Department of Environmental Protection

RE: Lena Road Landfill, Permit No. : SO41-211176, Manatee County
Financial Assurance Cost Estimates

Re Lena Road Landfill Stage III Gradient, Corrective Actions
Permit No.: SO41-211176, Manatee County

Benjamin L. Alex
Solid Waste Technical Coordinator

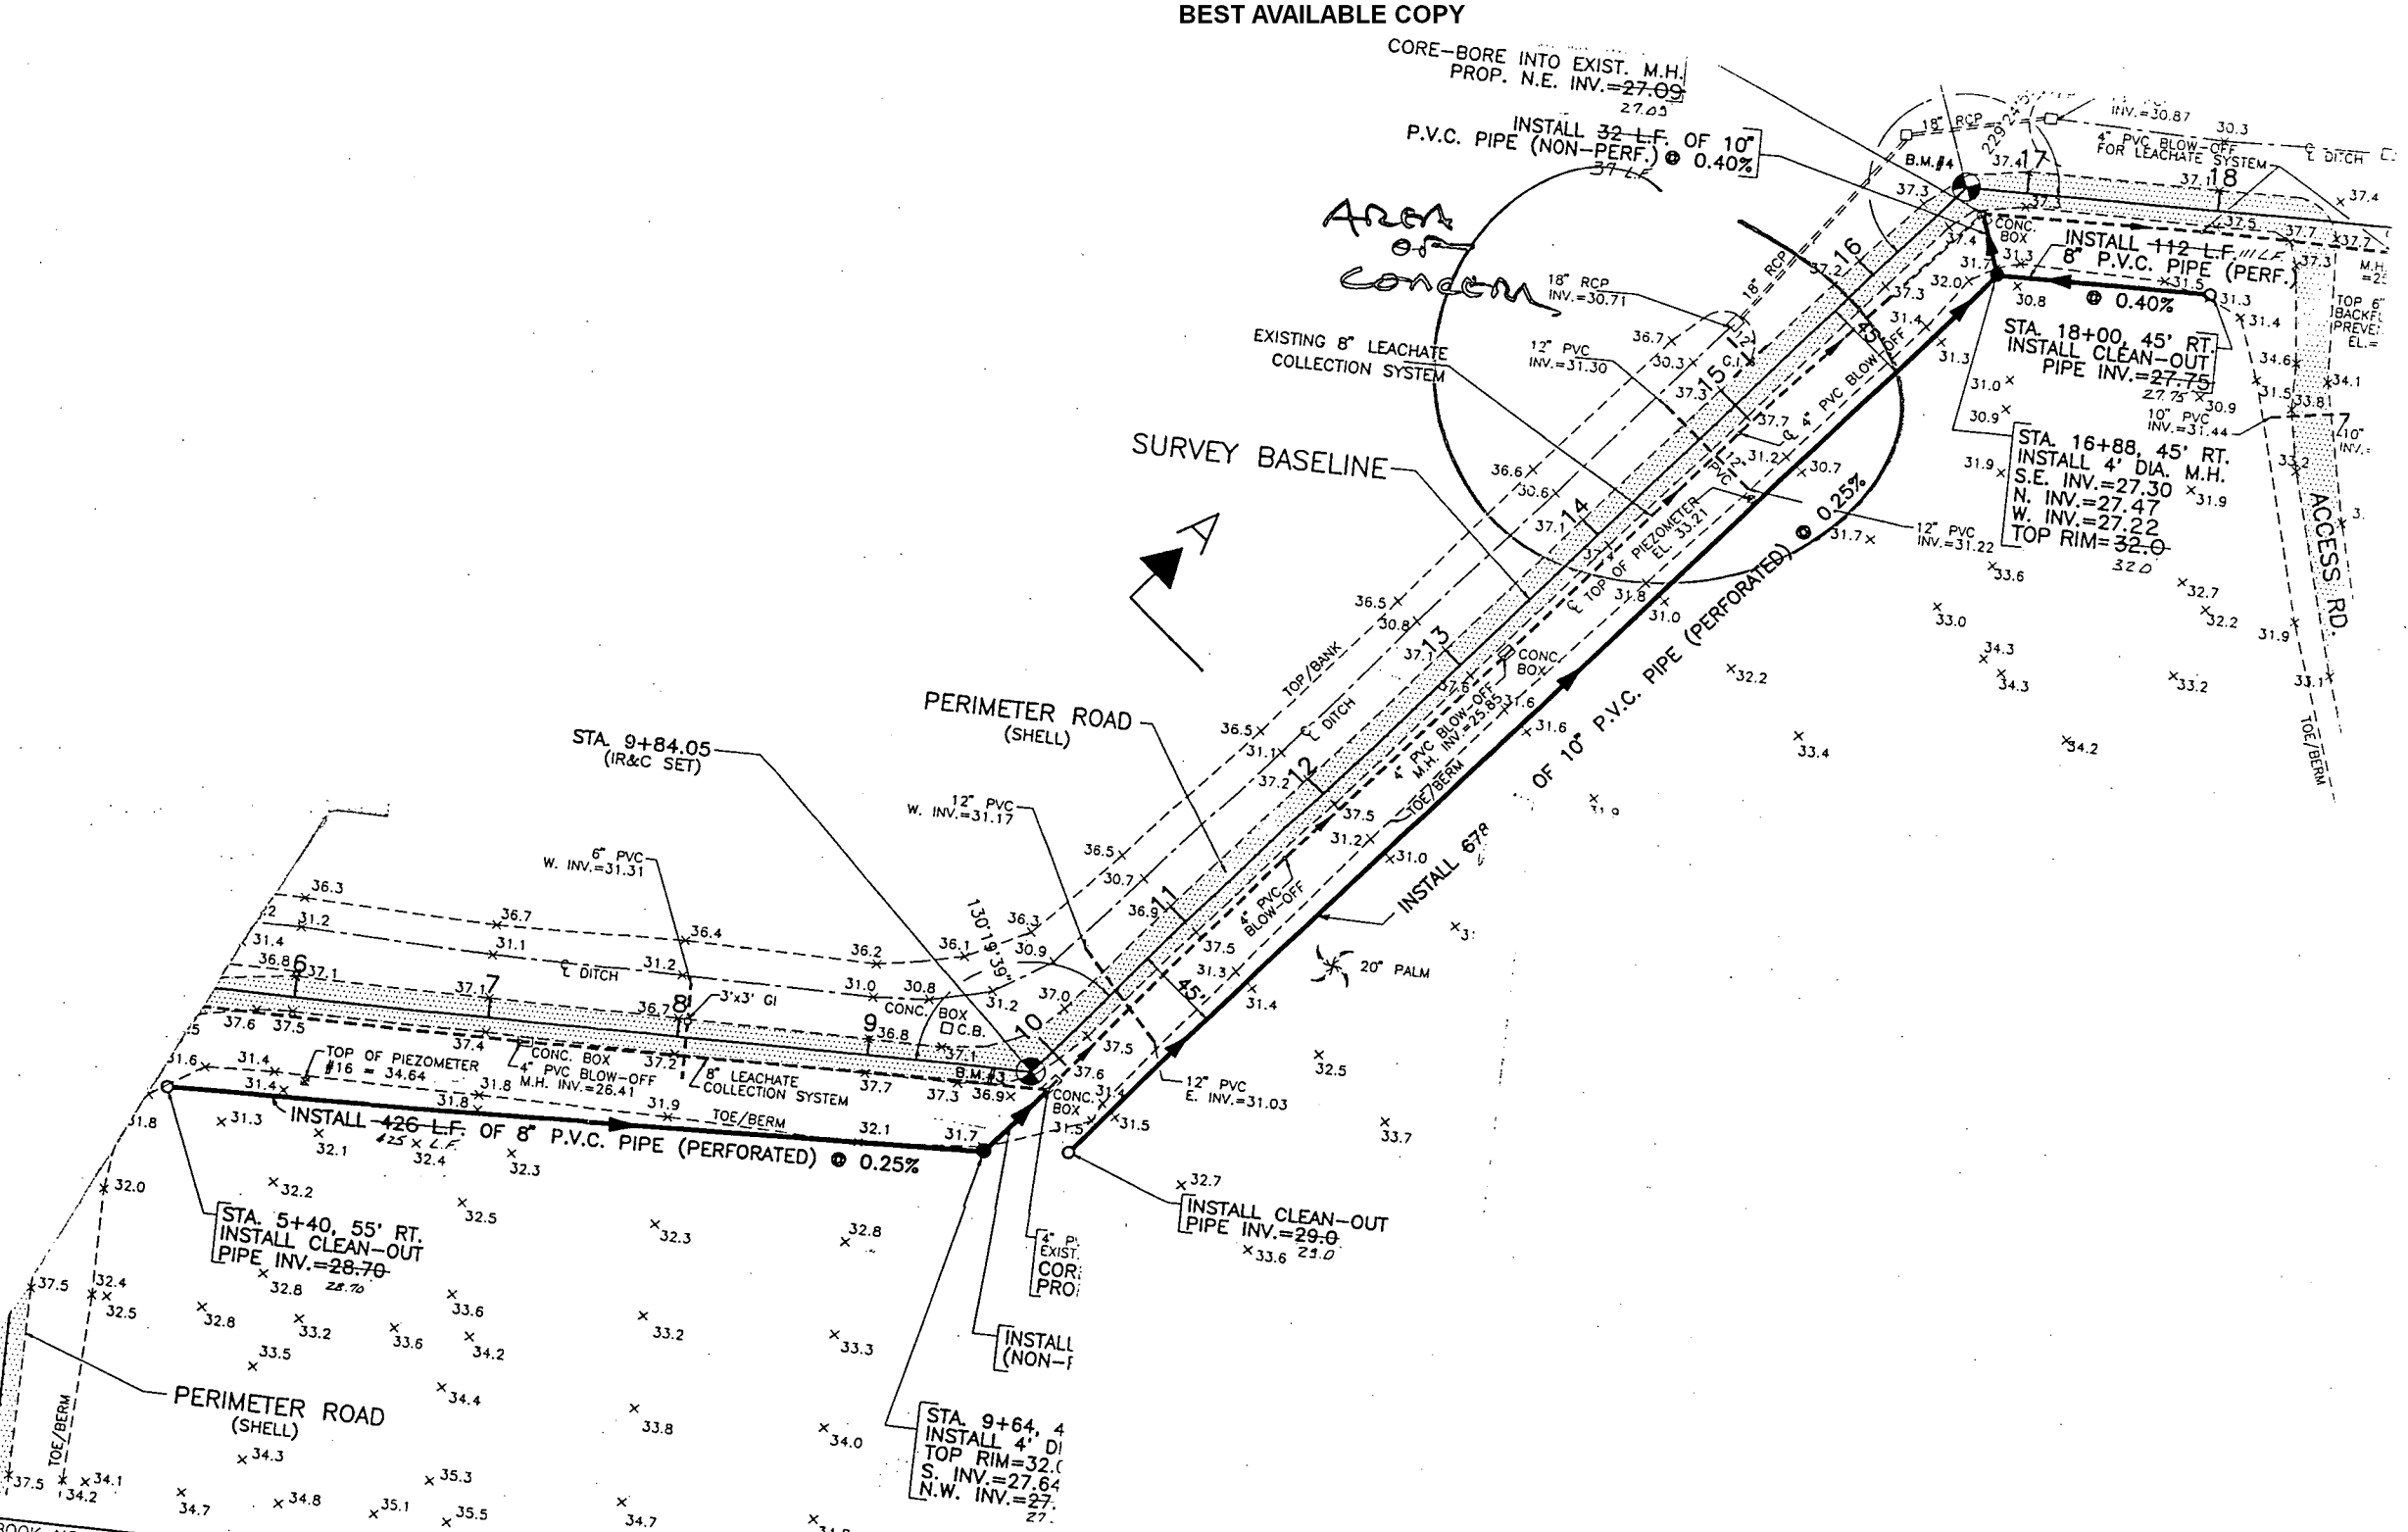
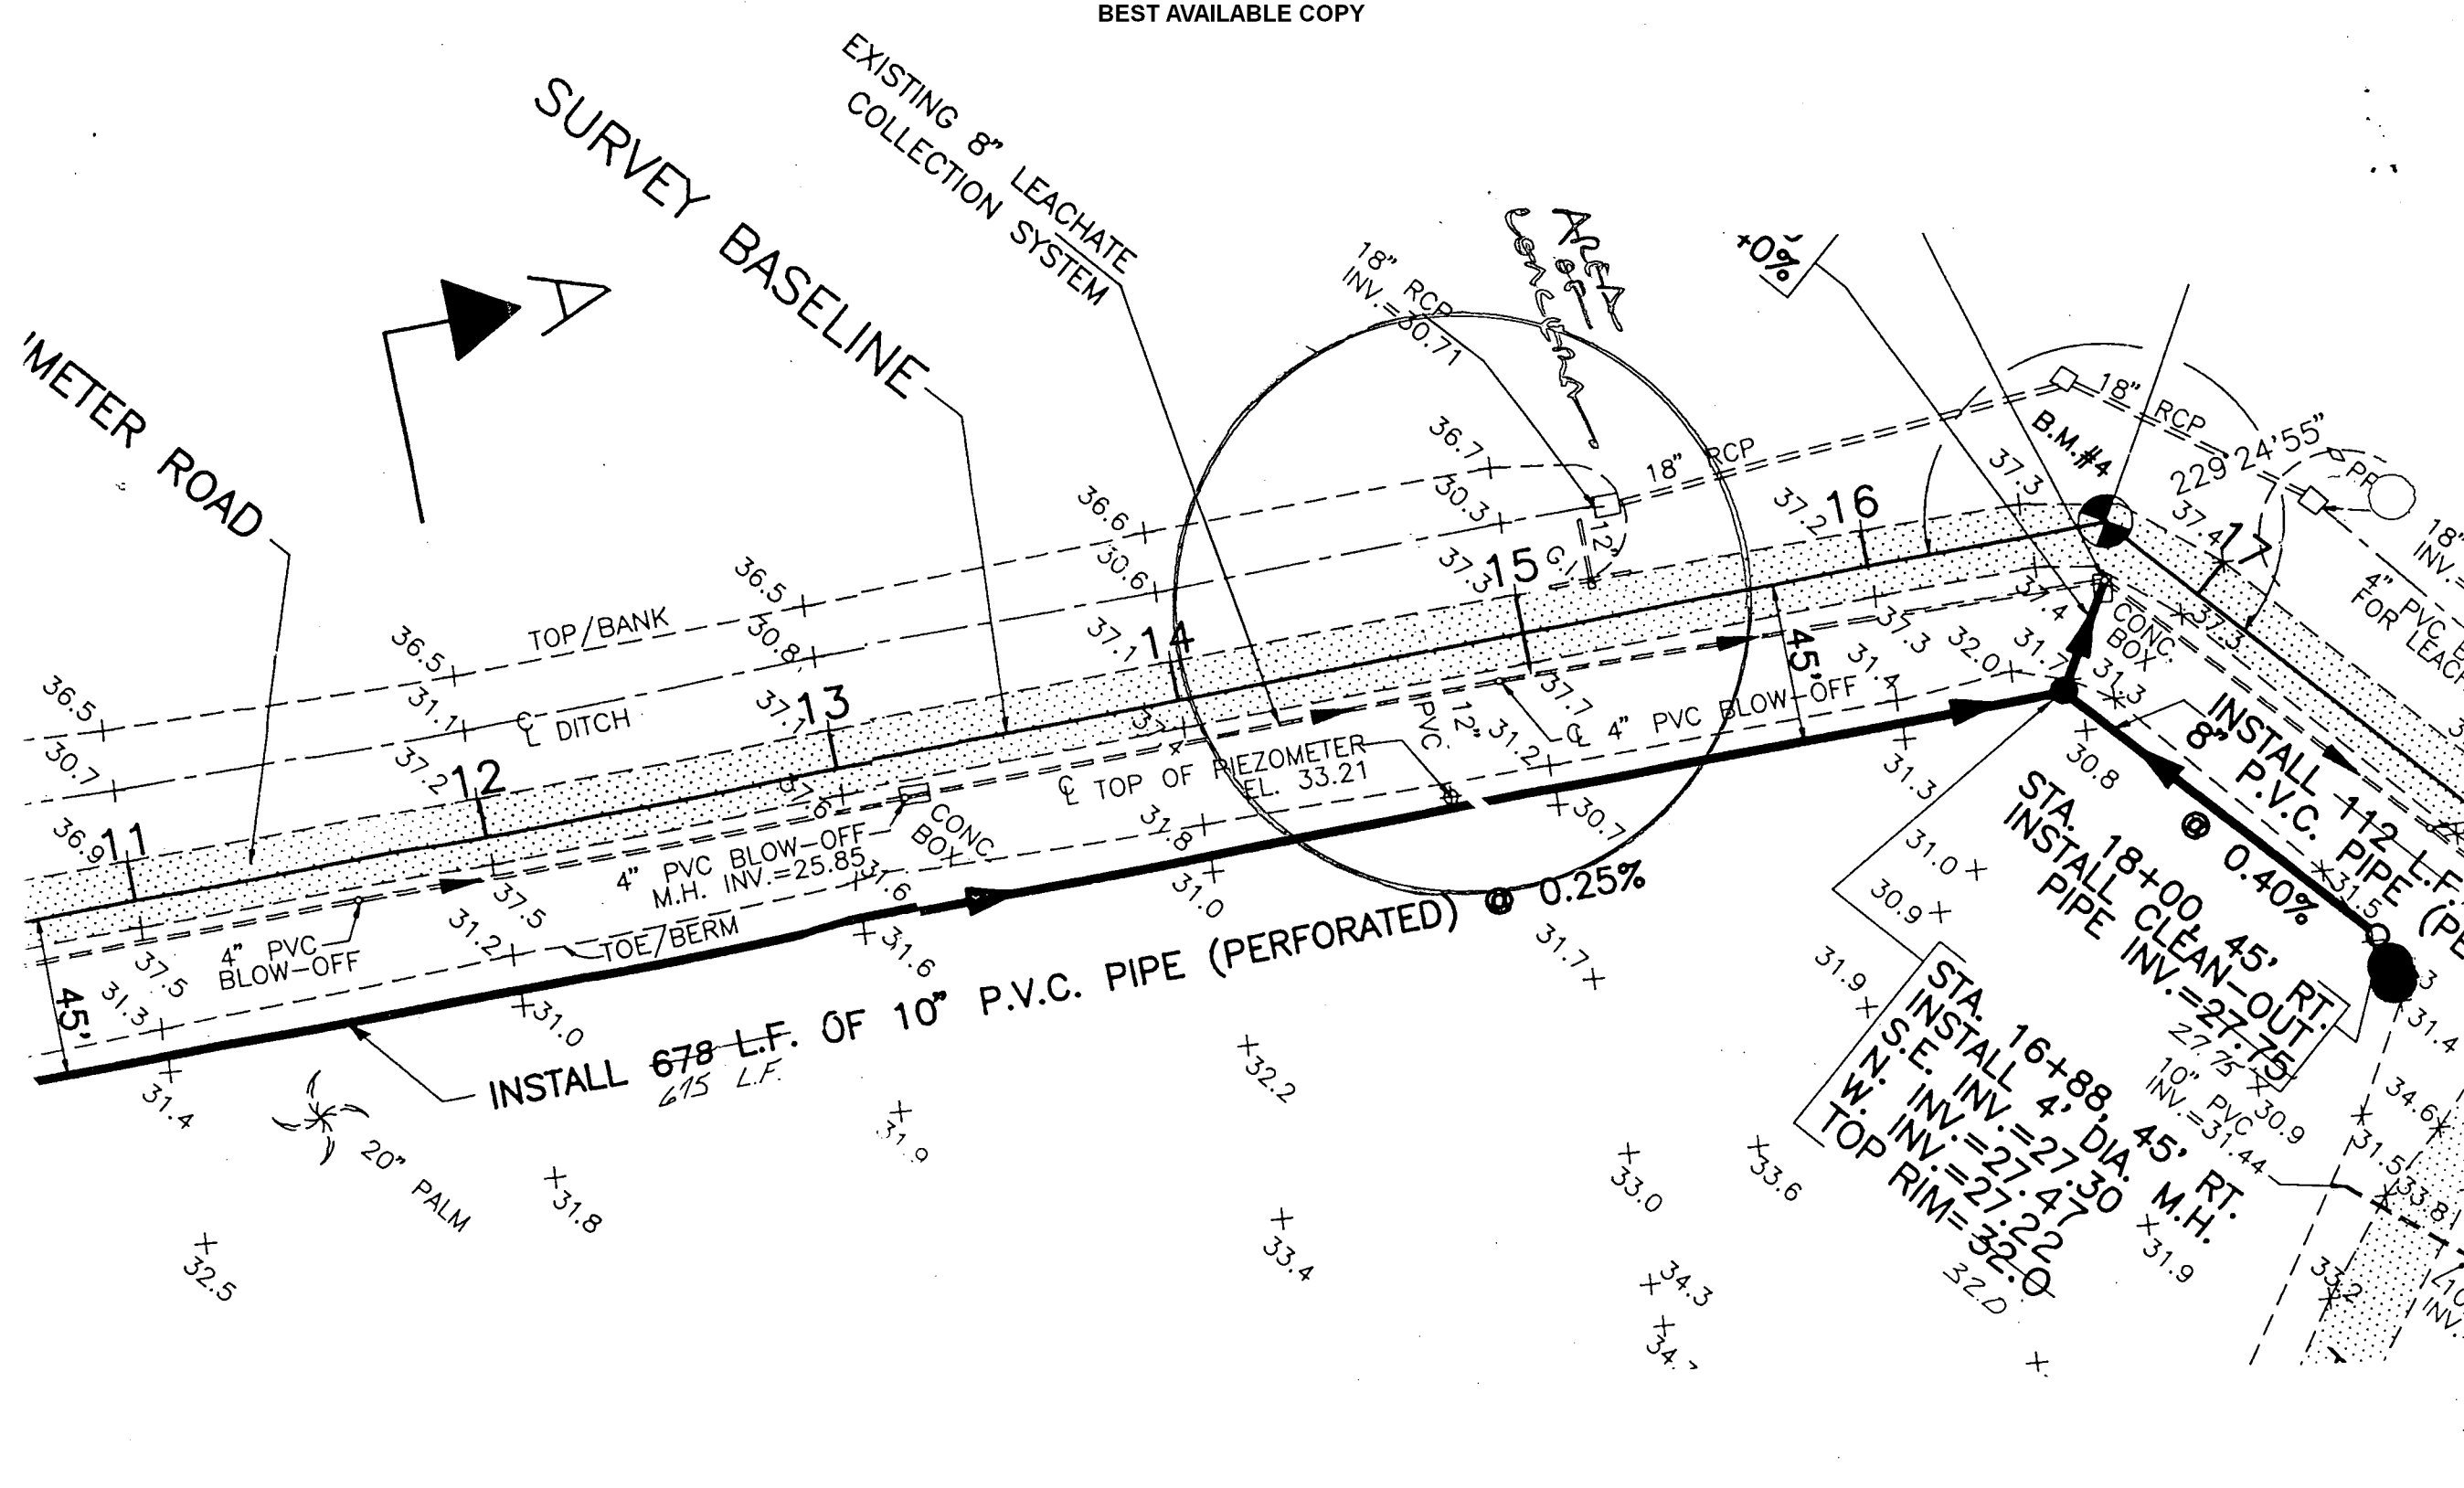
As discussed with you and verified with historical data, an outward gradient exist on the western side of Stage III, specifically at PZ-15. Refer to the attached map for details. In an attempt to reverse the gradient staff proposes the following:

- Construct a weir in the west storm water ditch of Stage III, at the location indicated on the map. The weir will allow storm water to backup along the entire west storm water ditch. The overflow for the weir will be approximately 3 feet above the ditch bottom.
- Once the weir is constructed, storm water from the storm water pond will be pumped into the ditch. A maximum head of 3 feet will be maintained in the ditch. As discussed, an inward gradient should result along the west side of Stage III if sufficient head is maintained in the ditch.

Staff proposes this change to the storm water system be temporary, only to determine if an inward gradient can be maintained. If an inward gradient is maintained, staff suggests the change become permanent and part of our storm water management system until a new design is implemented. If you require further information, or need assistance regarding this matter, please contact me at (941) 748-5543.

The Department has no objections to the corrective actions concerning the installation of a weir, ditch block or inlet type structure, in the Stage III stormwater conveyance swale and stormwater pumping (if necessary) as proposed in your September 12, 1997 letter subject to the following condition:

- Pumping of stormwater into the swale shall be controlled to maximize recharge in the swale, and to prevent the overflow and subsequent discharge of pumped stormwater from the swale.

The proposed activities are considered experimental and will serve as a demonstration to be used as the basis of approval as part of the permit application for landfill operation and maintenance. Therefore, a permit modification is not required. The Department appreciates all efforts being made to resolve this matter.
